Hardware History D424

Mother Board 1.866.120

Index 20 modification (for boards with layout 11 only) :

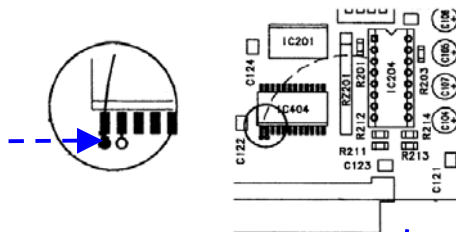
- cut track between IC 404 pin 1 and nearby contact hole
- solder wire to IC404.1, feed it through contact hole, and connect it to IC 204.3 on soldering side

SCSI Board 1.866.130.24

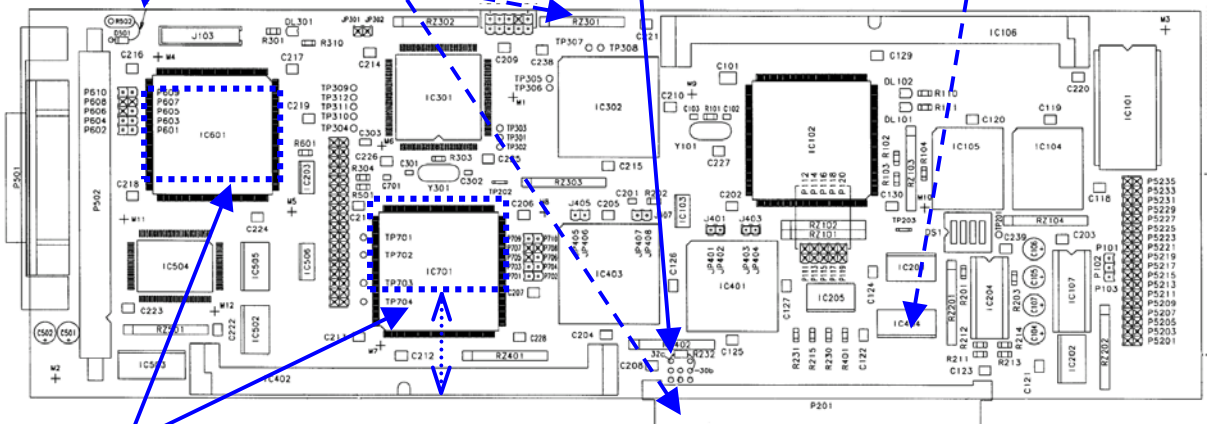
Index 26: Heatsink for IC 601/701, mounted with thermally conductive adhesive (99.01.3252)
IC 701 : min distance to bottom edge : 29 mm

Analog Input/Output 1.866.140

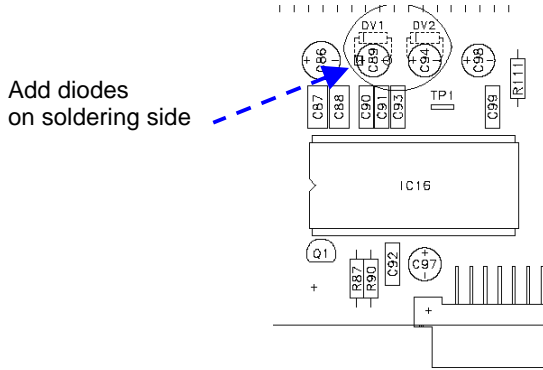
Index 20		
Rev A	22.3.2001	<i>protection of AD Converter CS-5390 in power-up phase :</i> - with additional zener diodes D10/11 (5.6V) in parallel to C89/C94 on soldering side

Keyboard 1.866.160

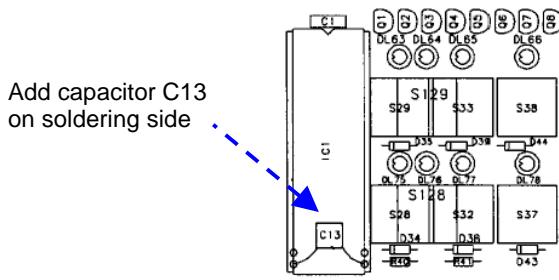
Index 00		
	8.6.1998	<i>improved crosstalk immunity for reliable IC2 function (Key/Display I/O)</i> with additional C13 (47pF) between IC1.20-21
